Re: Butler Supply
2736 NE McBaine Drive
Lee's Summit, MO 64064
Permit No.: PRCOM20251795

We have received your plan review comments and have itemized our responses to correspond with each comment.

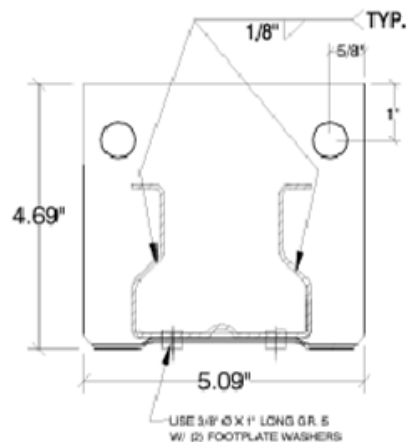
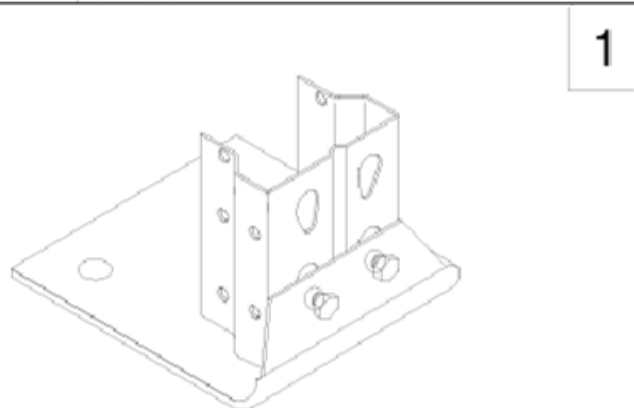
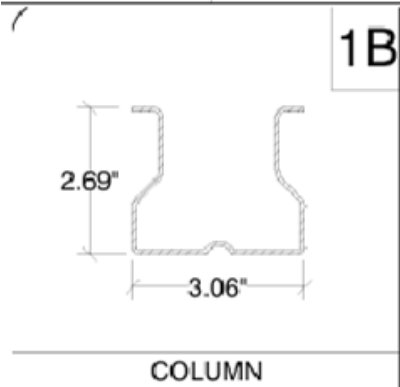
1. Please see the attached email with the diagram and highlighted note from the engineer of the roof truss manufacturer indicating that the existing roof structure is satisfactory to support the new condensing equipment.
2. Please see the attached engineered rack design detailing the way racks are to be attached to the floor.

NOTES:
CONFIRM O.A.L. OF ANCHORS WITH INSTALLER TO
ENSURE REQUIRED EMBEDMENT IS OBTAINED.

DESCRIPTION	HILTI KWIKBOLT TZ2 ANCHOR	NOTES: SEE NOTE #4 ABOVE FOR ANCHOR SPECS.
SIZE	1/2"Ø X 2-1/2" MIN. EMBED.	
ESR#	4266

NOTES:
USE @ ALL
COLUMN/BASE LOCATIONS TYP.
